**RUSSELL VALE COLLIERY
REVISED UNDERGROUND
EXPANSION PROJECT**

Submissions Report – Part B

Prepared by
Umwelt (Australia) Pty Limited
on behalf of
Wollongong Coal Limited

Figure 9-1 Predicted Pressure Head and Potentiometric Head Initial Conditions at Russell Vale East (North – South Cross Section on Easting 303000)

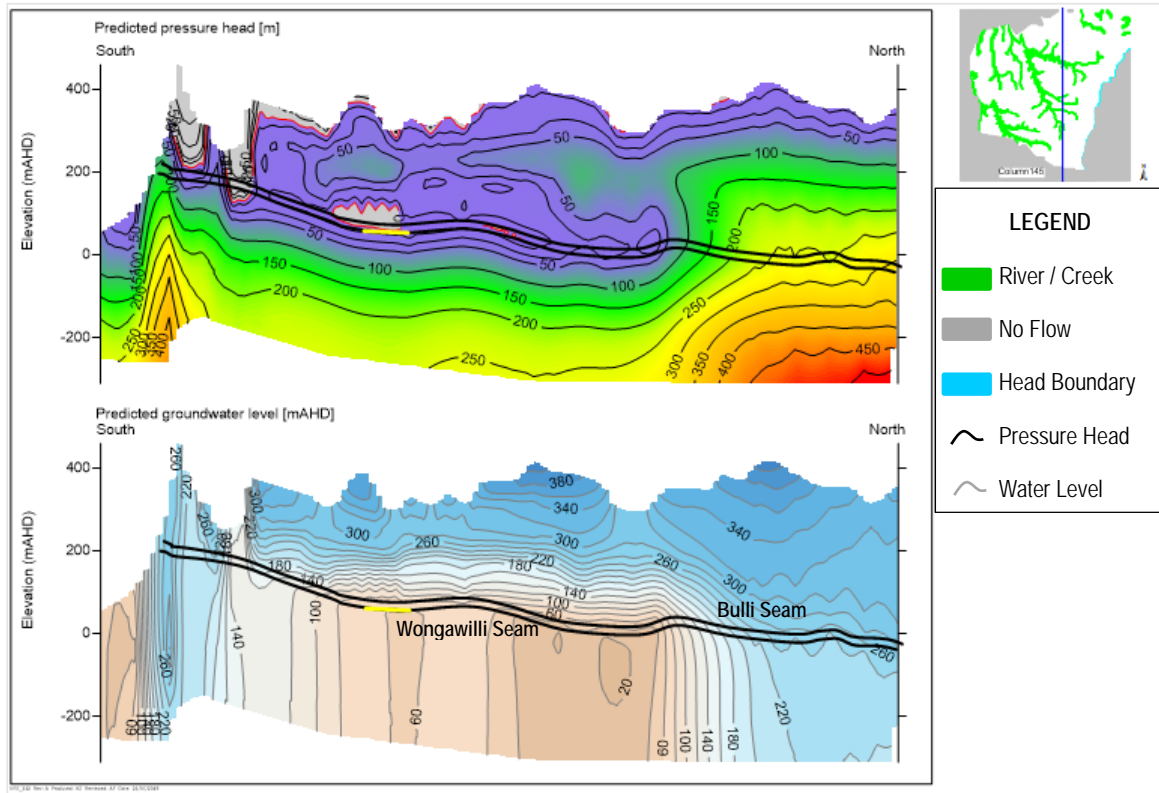
c. The schematic presentation of the conceptual model (Figure 9-1) is largely illegible and contains fundamental errors. For example, the springs shown on the right hand side in Figure 9-1 are hydrogeologically impossible.

Figures 9-1 to 9-6 show north - south and east – west cross sections of the overall modelled hydraulic head (m) and groundwater levels for modelled initial conditions, at the end of LW6 extraction and at the end of proposed mining at Russell Vale East.

Figures 9-1 and **9-2** show initial conditions, and de-saturated areas underlying the escarpment in the south-eastern area of the model. Zero pressures also extend into the Bulli Seam and overburden due to pre-existing mining voids from the lengthy period of mining in the region prior to the model simulation period.
